Modification Recommended Service Note

Supersedes:
DSOS204A-02D

DSOS204A – DSO Infiniium S Series 2GHz 4 channel

The Problem – Under certain circumstances a PLL2 error may occur on the S-series products.

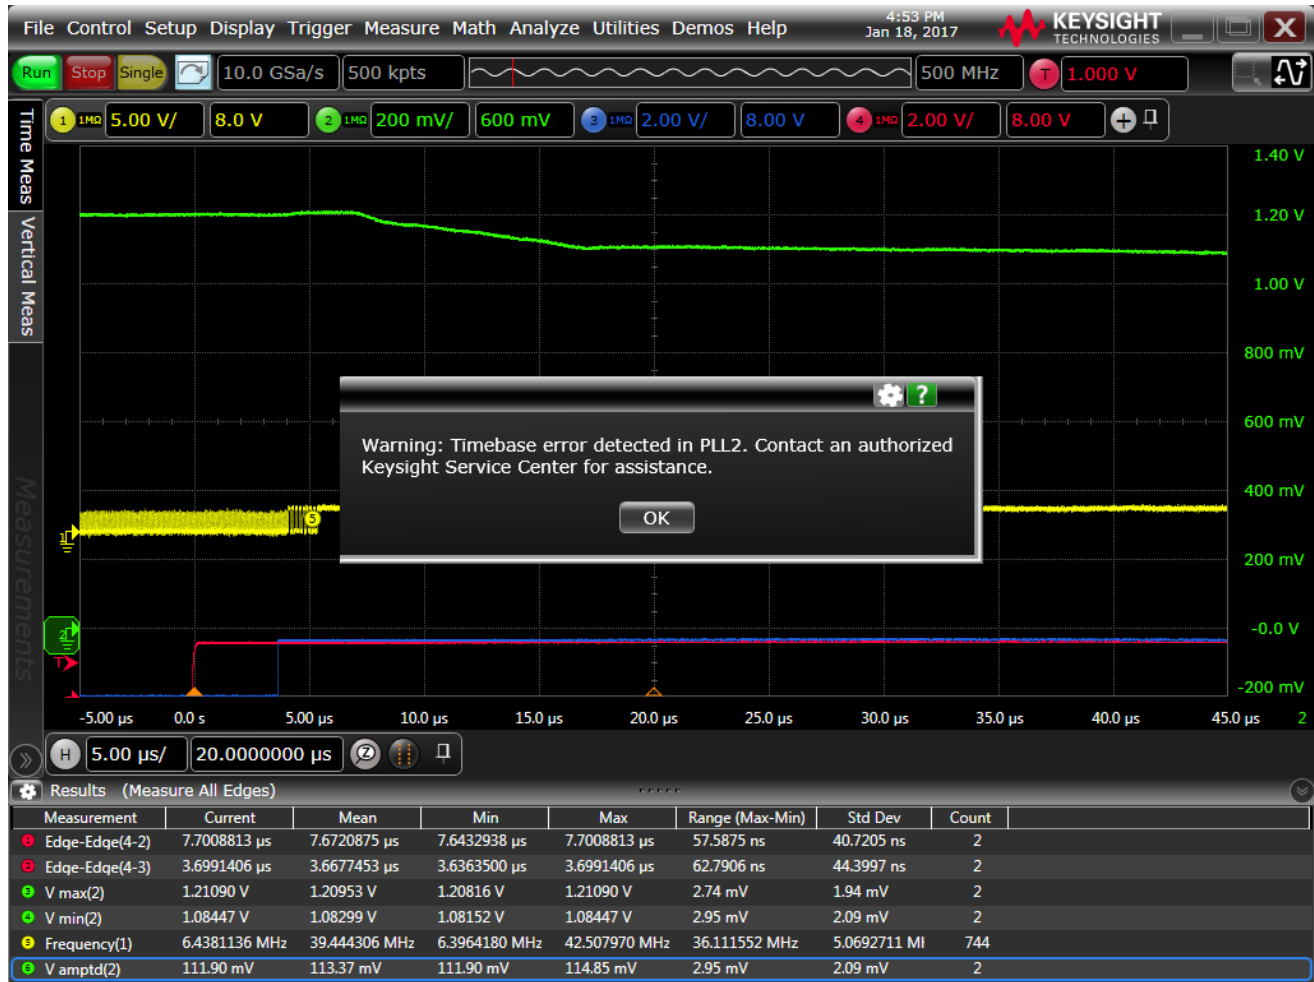
On older acquisition boards a PLL2 error message sometimes occurs. The error message appears on the screen as below:

There are new acquisition boards that fix this issue for the S-series scopes.

Please, use the 54911-69511 board until is gone.
If you have a 54911-69511, then skip steps 1 and 2 and proceed to step 3.
If there are no 54911-69511, then start with step 1 below.

1. If the customer needs to have software revision < 6.10.01001, then replace the acquisition board with the 54911-69532 board.
2. If the customer can have software revision \geq 6.10.01001, then it can be replaced by any of these three boards: 54911-69521, 54911-69531, or 54911-69532.
